FIRE SAFETY AUDIT

Company: Gateways School	Date of Risk assessment Visit: 22 nd September 2022
Address: Gateways School Harewood Leeds LS17 9LE	First Fire Risk Assessment: June 2011 Last Audit: August 2021 Comments: 31 st
Responsible Person: Dr. Tracy Johnson; School Principal	Those items indicated by an asterisk (*) are contraventions of The Regulatory Reform (Fire Safety) Order 2005 and as such may become the subject of a prosecution following an inspection by the Local Authority Fire Brigade or enforcing authority as appropriate. Accordingly, those items must receive immediate attention.
Contact: Phil Robinson Operations Manager	
Fire Safety Consultant: Michael J Pierce. Grad.I.FireE., M.I.F.S.M., FRACS Ex District Officer West Yorkshire Fire Service. Fire Safety Managers Fire Risk Assessor register. Listing 0007 Warrington Certification Ltd, F.R.A.C.S. Risk Assessor's Register, Listing 0020	Is there risk of enforcement action: <input type="checkbox"/> Yes <input checked="" type="checkbox"/> No

Figure 1

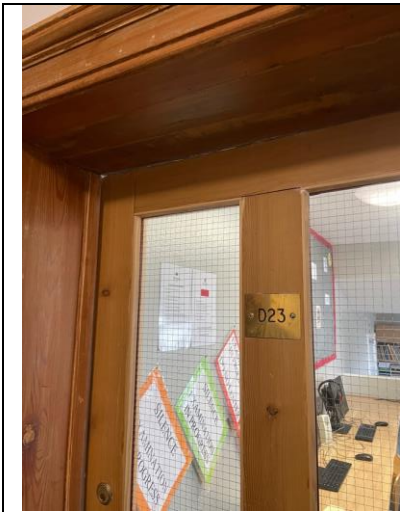
SIGNIFICANT HAZARDS	PERSONS AT RISK	ACTION REQUIRED	WHEN	PHOTO	BY WHOM (SIGNATURE)
5.1 Means of Escape					
a. Some doors are showing excessive gaps beneath the, eg. Door to room D23, and the corridor division door shown in figure 4	ALL OCCUPANTS	a. All doors which protect the means of escape need to be installed in accordance with accepted parameters. These are that gaps around the sides and top are between 2 and 4mm. Gaps at the bottom of doors should be preferably 8mm but no more than 10mm. The doors should also close fully into their frames from any angle of release	IMMEDIATE	1, 4

D23, does not close effectively and there are gaps at the top.

Figure 2

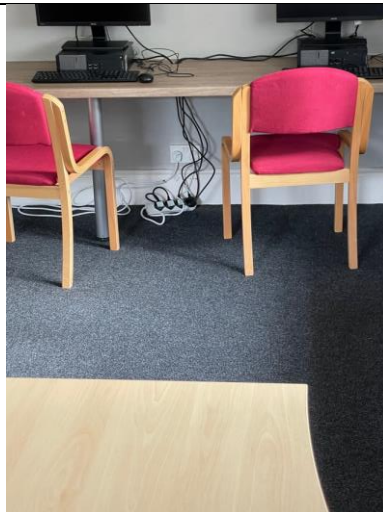
5.6 General Housekeeping/ Maintenance					
<p>The new computer suite in the old building has been set up with reliance upon trailing sockets.</p>	ALL OCCUPANTS	<p>It is recommended that a competent electrical engineer be appointed to evaluate the specific requirements of the installation. His recommendations should be carried out.</p>		2

Over use of trailing sockets.

Figure 4

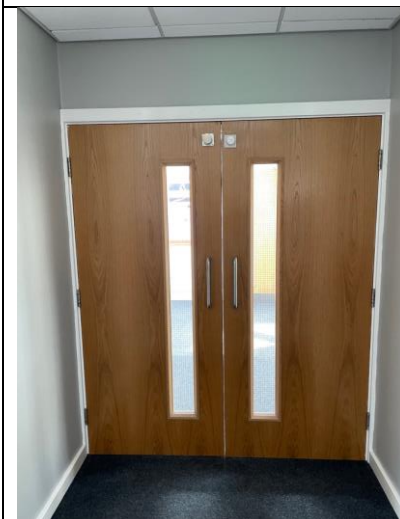
Gaps between fire check corridors.

Figure 9

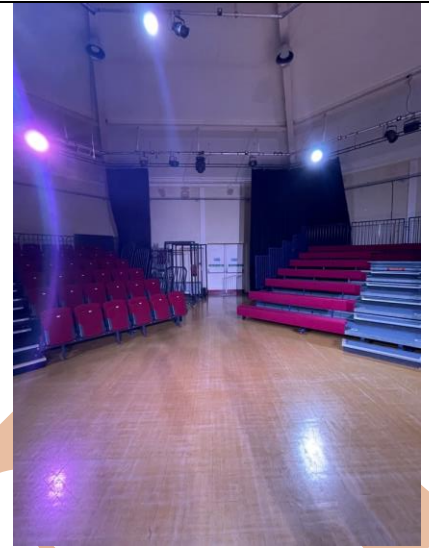
Theatre signage not sufficient
